**Interim Verification Report
Investigation of
Peoples Gas Pipeline Safety Program**

Illinois Commerce Commission

October 2, 2009

Reduce the year-end leak backlog.

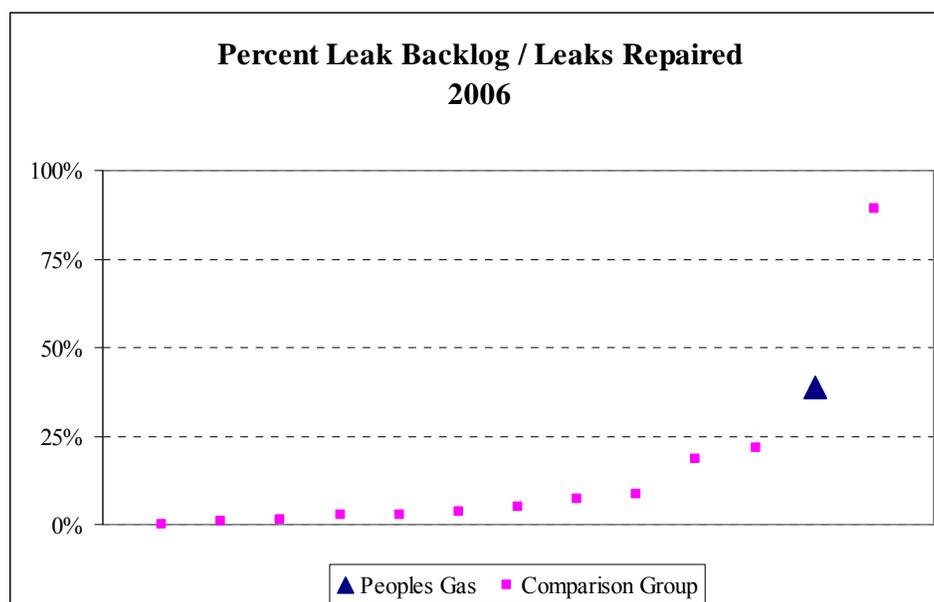
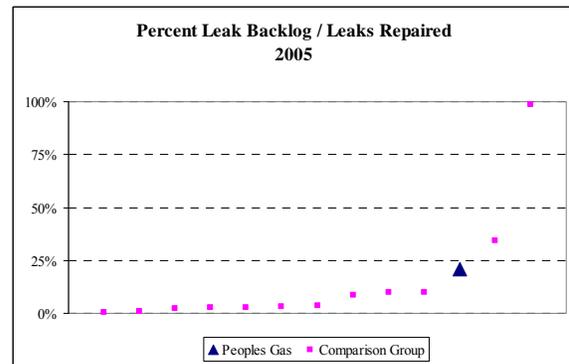
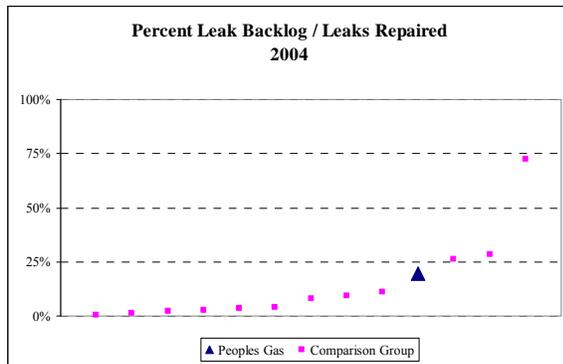
Peoples Gas needs to repair more leaks and reduce the level of backlogs at year-end. In both relative terms, compared to its peers, and absolute numbers of leaks outstanding, Peoples Gas' leak backlog is too high. Peoples Gas should reduce the backlog so that the percentage of the leaks in backlog at year-end is less than 10 percent of the number of leaks repaired during the year. Peoples Gas should develop and implement a written plan for meeting this recommendation. The plan should include specific goals for reducing leak backlogs and repairing more leaks, including target levels for leak backlogs at year-end for the current and following two years.
